35/36-05A 5808 Warwick Place
Somerset Historic District

SUBJECT: Historic Area Work Permit Application # 371248

HISTORIC PRESERVATION COMMISSION STAFF REPORT

Address:	5808 Warwick Place, Chevy Chase	Meeting Date:	03/09/05
Applicant:	Bonnie Thomson/Eugene Tillman (Gregory Wiedemann, Architect)	Report Date:	03/02/05
Resource:	Contributing Resource Somerset Historic District	Public Notice:	02/23/05
Review:	HAWP	Tax Credit:	Partial
Case Number:	35/36-05A	Staff:	Tania Tully
PROPOSAL:	Rear addition & landscaping	RECOMMENDATION:	Approve with conditions

WARWICK PLACE

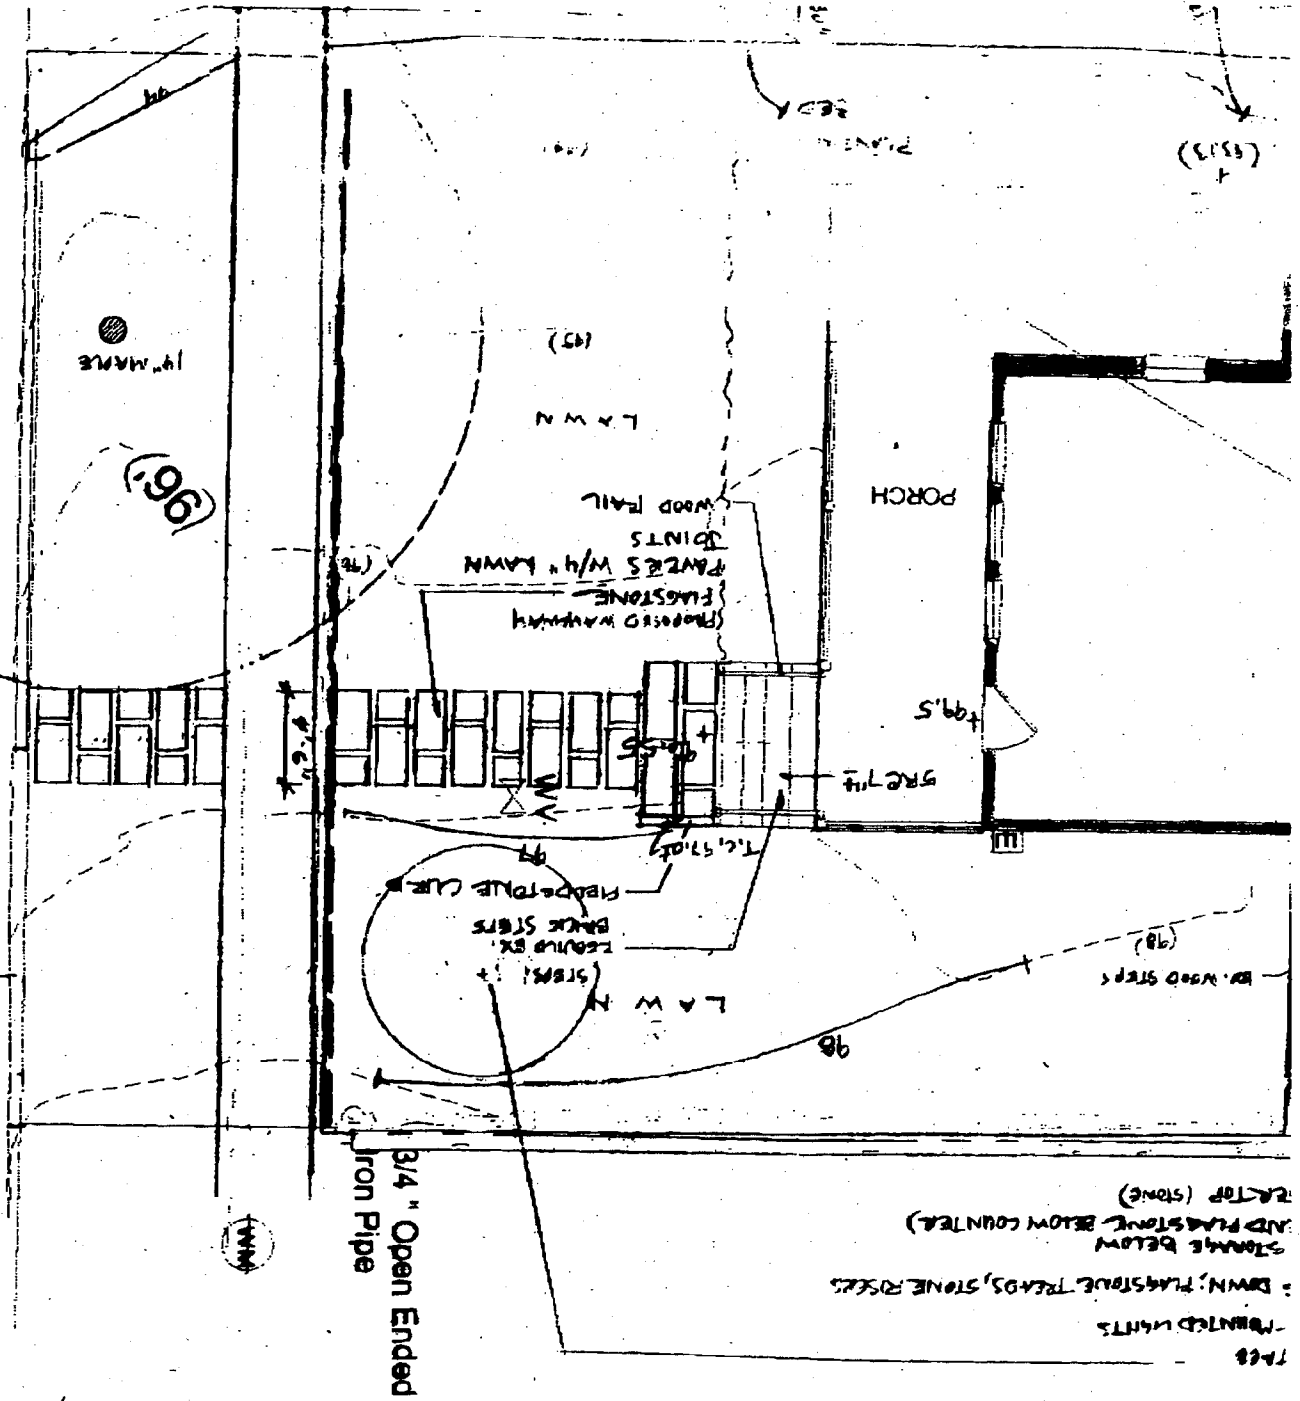
As the request of Bonnie Thomson, I am attaching a revised partial plan of her front garden showing rebuilt brick steps at her front porch. She is interested in rebuilding these, but widening them to accommodate the new wood handrails.

Please review this sketch and let us know if this design would be approved. We would like to have your comments on whether this would be approved sometime Monday, as the Town of Somerset hearing is on Monday evening.

Kim - drive material questions

Caroline - dark / earth tint color of concrete pavers + strip

Lynn - drive over lights?

Steve - amt of impervious material? - lot coverage

Julia - strips a good improvement

Caroline - thanks for looking @ options - color + strip

Kim - reduction of sq. ft. - would like to have seen more
sun - arund is more invasive

Jef - massing still too big - garage larger than average

1. The applicant will file for and receive all applicable permits from the Town of Somerset
2. If changed, the front steps will be replaced with wood rather than stone.
3. Tree protection measures will be implemented prior to beginning any work on the property
